Palisades Nuclear Plant
Operated by Nuclear Management Company, LLC

Palisades Nuclear Plant
Docket 50-255
License No. DPR-20

90-Day Response to Request for Additional Information RE: Steam Generator Tube Integrity Assessment from the 2003 Refueling Outage (TAC NO. MC2747)

ENCLOSURE 1
90-DAY RESPONSE TO REQUEST FOR ADDITIONAL INFORMATION RE:
STEAM GENERATOR TUBE INTEGRITY ASSESSMENT
FROM THE 2003 REFUELING OUTAGE

Figure 1: Steam Generators With Naming Conventions

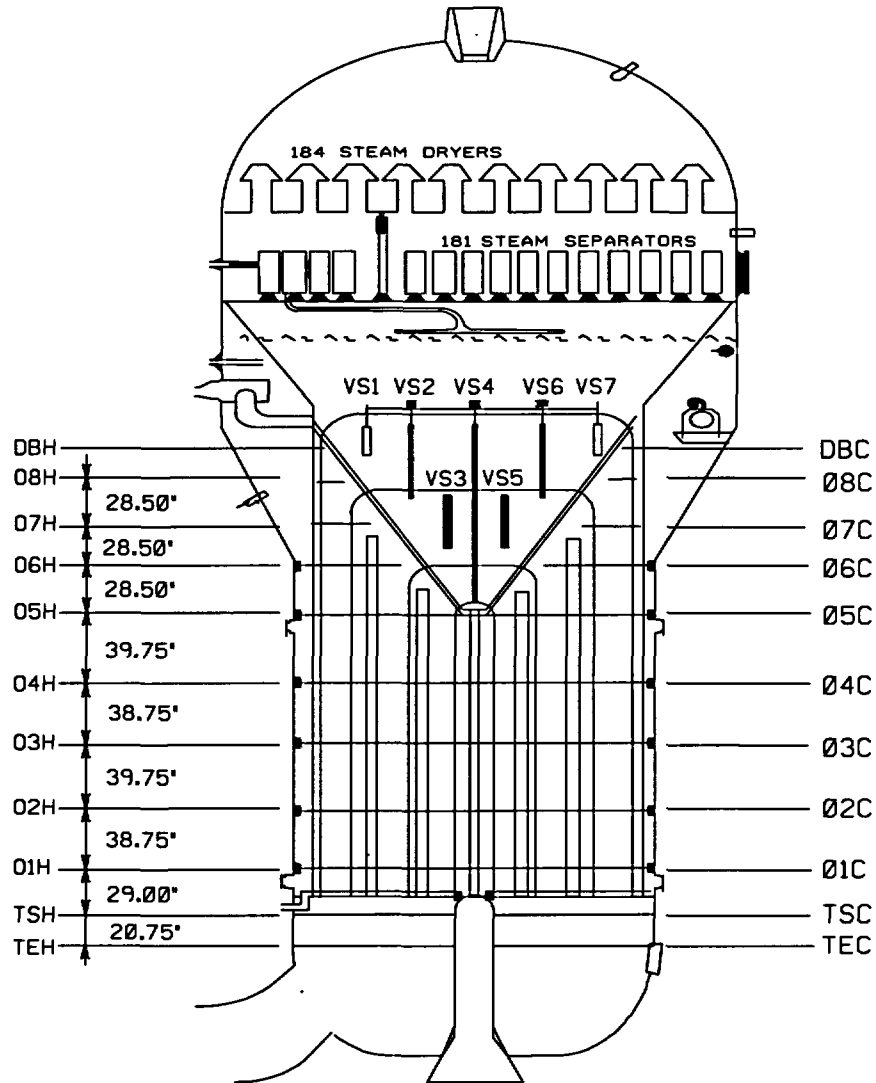
- 1. Provide a general description of the replacement SGs, include in this general description the total number of tubes, tube diameter, tube wall thickness, tube pitch, tube support thickness and any other noteworthy design characteristics from a SG tube integrity standpoint (e.g., full length stress relieved of the row 1 through 10 tubes). In addition, provide sketches of the steam generators that depict the tube support naming conventions and tubesheet maps that depict the rows and columns of the tubes.***

- 1. The steam generators (SG)s that are currently in use at the Palisades Nuclear Plant are replacement Combustion Engineering (CE) SGs, Model 2530. The replacement SGs were installed in the fall of 1990. The tube material is mill annealed Alloy 600 with a 0.75-inch outside diameter and a 0.042-inch tube wall thickness. Each SG has 8219 tubes. The tubes were expanded through the full depth of the tubesheet using an explosive process. The tube bundle is supported by stainless steel eggcrate lattice type supports comprised of horizontal eggcrate supports, vertical straps and diagonal straps. The thickness for all supports and straps is 0.090 inches. The SG tube pitch is 1.0-inch. Tube rows 1-18 are U-bends and rows 19-165 are square bends. The SG tubing has not been thermally treated.**

Attachment 1 provides sketches of the steam generators that depict the tube support naming conventions and the tubesheet maps that depict the rows and columns of the tubes.
